Access Compliance Report Public Rights-of-Way (Curb Ramps)

Main Street: FOWLER_AVE Cross Street: KINGSVIEW_RD Location: NW

ADA ID: RPRK211229115828 Ramp Type: Type 4 - Parallel Initial Pass/Fail: Fail Overall Compliance: No Severity Score: 60

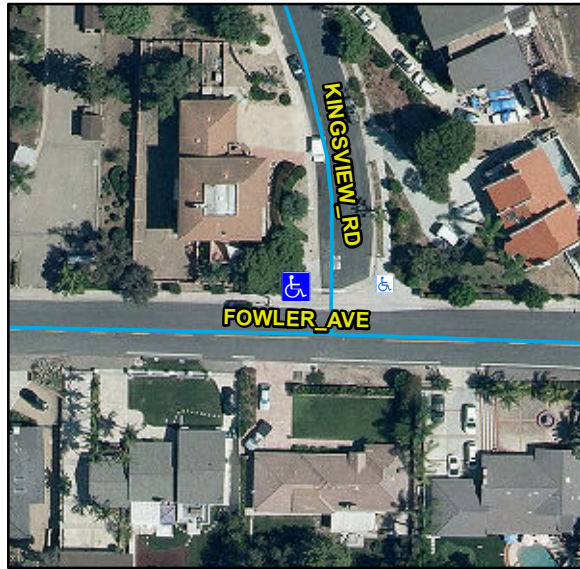
Compliance	Description	Data	Compliance	Description	Data
N/A	Ramp Length LT (in)	94	N/A	Ramp Length RT (in)	89
Yes	Ramp Width LT (in)	99	Yes	Ramp Width RT (in)	99
No	Ramp Run Slope LT (%)	11.9	No	Ramp Run Slope RT (%)	12.5
No	Ramp Cross Slope LT (%)	7.8	Yes	Ramp Cross Slope RT (%)	1.2
N/A	Landing Present	N/A	N/A	DWS Provided	N/A
N/A	Landing Length (in)	N/A	N/A	DWS Contrast	N/A
N/A	Landing Width (in)	N/A	N/A	DWS Length (in)	N/A
N/A	Landing Run Slope (%)	N/A	N/A	DWS Full Width	N/A
N/A	Landing Cross Slope (%)	N/A		DWS Offset Type	N/A
N/A	Landing Movement Obstructed?	N/A	N/A	DWS Offset Left (in)	N/A
	Landing Movement Type	N/A	N/A	DWS Offset Right (in)	N/A
N/A	Landing Shared	N/A			
N/A	Clear Space	Yes			
N/A	Clear Space To Crosswalk (in)	N/A			
N/A	Marked Crosswalk 1	No	N/A	Marked Crosswalk 2	No
	Crossing 1 Direction	S		Crossing 2 Direction	E
	Marked Crosswalk 1 Width (in)	N/A		Marked Crosswalk 2 Width (in)	N/A

Remove & Replace Curb Ramp With Two New Directional Ramps or Equivalent.

R304.3.2, R304.5.3, STD 1115
